SANTA ROSA DESIGN REVIEW BOARD MINUTES REGULAR MEETING CITY HALL, 100 SANTA ROSA AVENUE FEBRUARY 16, 2017

6.2 CONCEPT DESIGN REVIEW – RESIDENCE INN BY MARRIOTT 0 BROADACRE CIR – FILE NO. DR16-056

RESIDENCE INN SANTA ROSA by MARRIOTT

DATE 2/2/TI
JOB 2016-94
SCALE 1'-30'
DRAPN: DM
SHEET
L-1

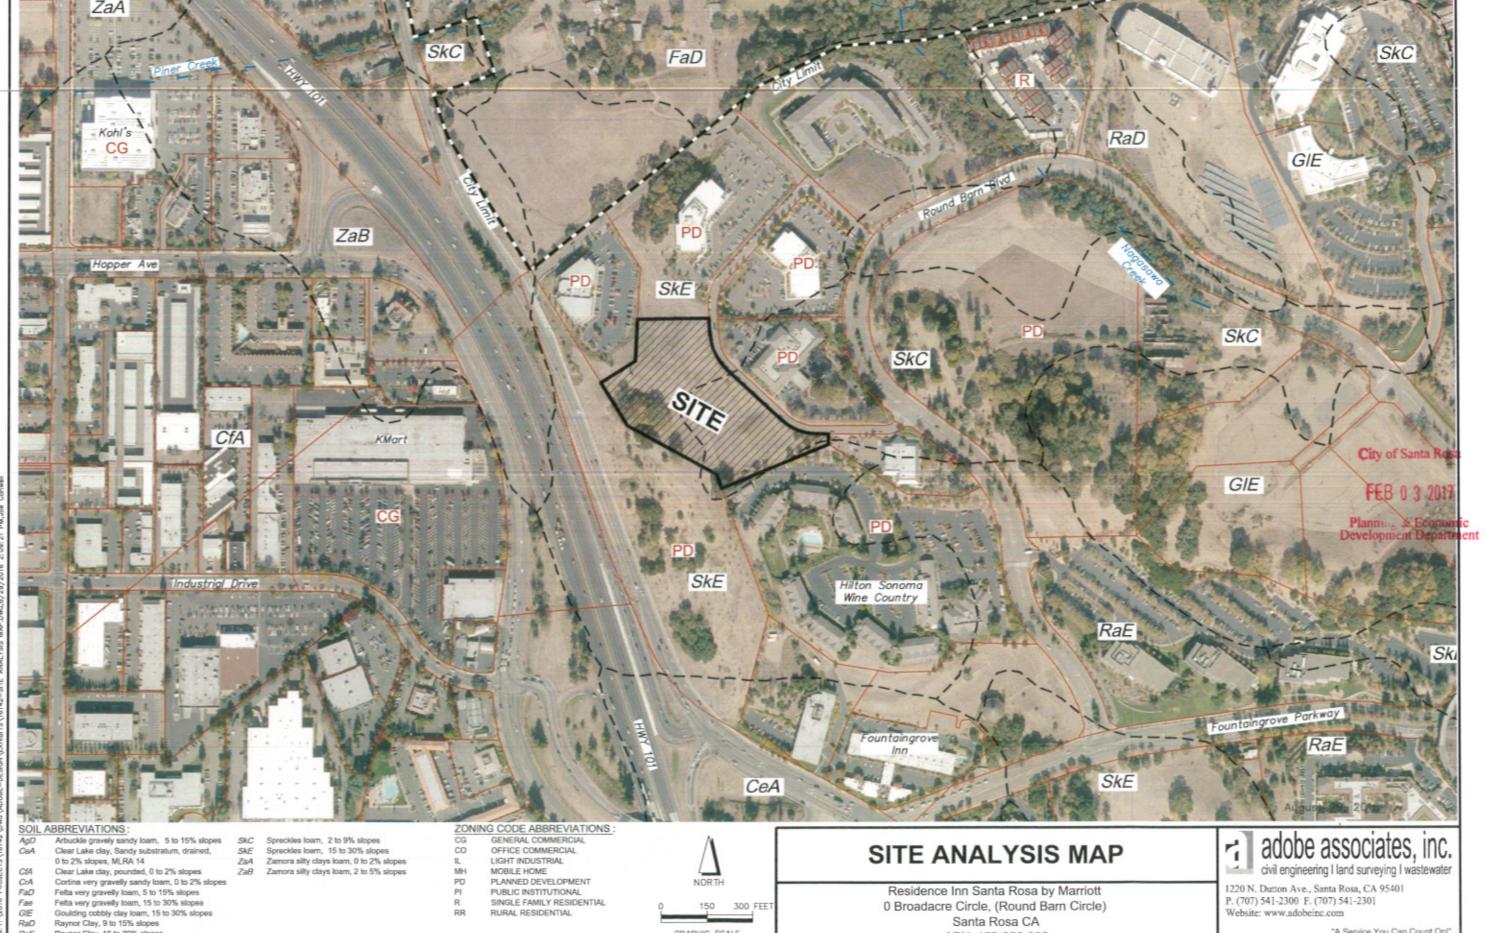
The Board recommended a varied roofline, larger shrubs at the retaining walls, richer colors and material variety, and suggested reducing the number of rooms if needed, to break up the building mass, soften the corners, and increase fenestration. The Board emphasized the importance of the west elevation, and the need to reduce the visual impact from Highway 101 and Redwood Highway. The Board recommended lowering the tower height. Explore the entryway orientation and width. Plant more Oaks of varied size on the slope to tie in with the existing Oak grove. Show more varied wall materials at the next submittal.
